<b>Docket Number:</b>	20-FDAS-01
<b>Project Title:</b>	Flexible Demand Appliance Standards
<b>TN #:</b>	236562
<b>Document Title:</b>	PG&E Comments - on Staff Paper SB 49 Flexible Demand Appliance Standards
<b>Description:</b>	N/A
<b>Filer:</b>	Patty Paul
<b>Organization:</b>	PG&E
<b>Submitter Role:</b>	Public
<b>Submission Date:</b>	2/2/2021 9:09:08 AM
<b>Docketed Date:</b>	2/2/2021

**Re: Pacific Gas and Electric Company Comments on Staff Paper Senate Bill (SB) 49 Flexible Demand Appliance Standards (Docket No. 20-FDAS-01)**

**Figure 1: Connected Water Heater Product (CWHP)**

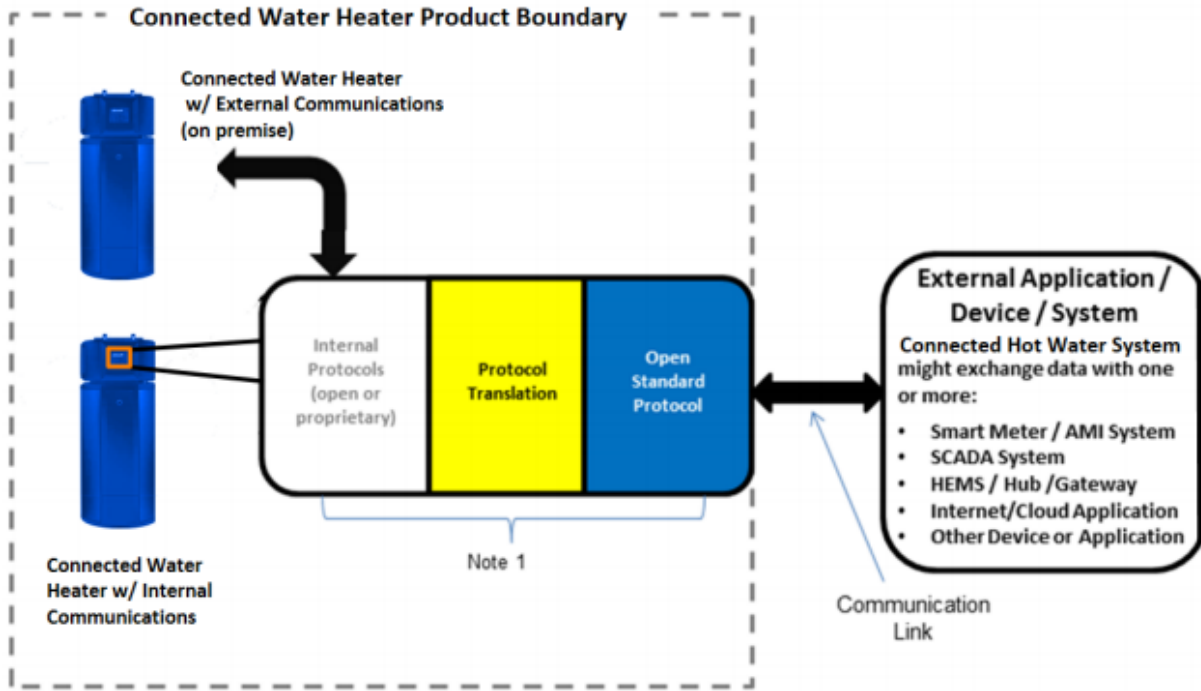
In addition, PG&E recommends the CEC to reference the Energy Star Connected appliance communication and load control requirements as indicated in the diagram below (connected water heater was demonstrated, but the requirements can apply to all flexible appliances):
